SERVICE BULLETIN SPSB009

SUBJECT: SUPPLIER/VENDOR RECALL OF PS70104 HOUSINGS (METAL FLEX HOISING INC)

STATUS: MANDATORY INSPECTION AND REPLACEMENT OF RECALLED HOUSINGS

WEARERS LEFT SIDE:

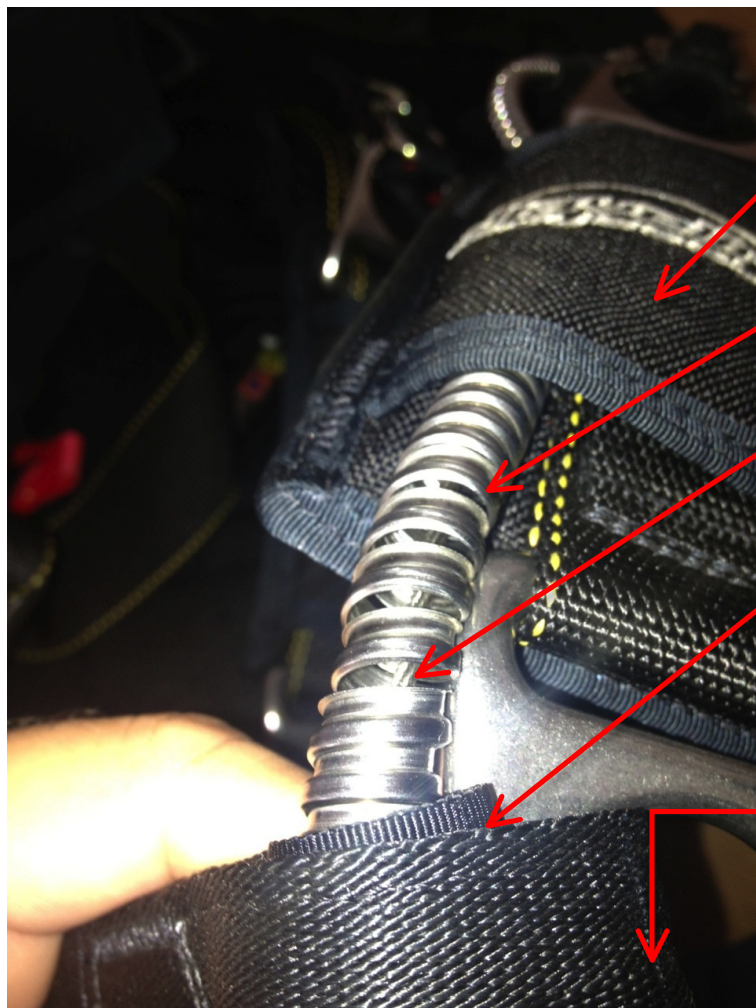
RESERVE RIPCORD HOUSING (LOWER END)

SEPERATED HOUSING (FOR REFERENCE)

What to inspect: All JA101-XX harness container systems listed in table above. Inspect Reserve Ripcord housing.

If the serial number is listed in the above table, inspect the available exposed reserve ripcord housing. Locate the lower end of the housing, which is clamped to the Main Lift Web, just above the reserve ripcord pocket. Inspect the exposed length of housing from the clamp upwards; ensure that the coil has not separated/unraveled. Be sure to inspect the section that is routed through the chest strap.

A. **HOUSING FOUND TO BE INTACT (GOOD):** The rig may continue to be jumped with periodic monitoring until the next repack cycle or earlier elective replacement. However this housing must be replaced at the next repack cycle. See <http://www.sunpath.com/support/HousingReplacement.pdf> for instructions for your rigger to complete the replacement of the housing.

B. HOUSING FOUND TO BE SEPERATED/UNRAVELLED (BAD): The housing must be replaced before the next jump by a certificated senior or master parachute rigger (or foreign equal) or the manufacturer. See <http://www.sunpath.com/support/HousingReplacement.pdf> for instructions for your rigger to complete the replacement of the housing or instructions to send your system back to the manufacturer.
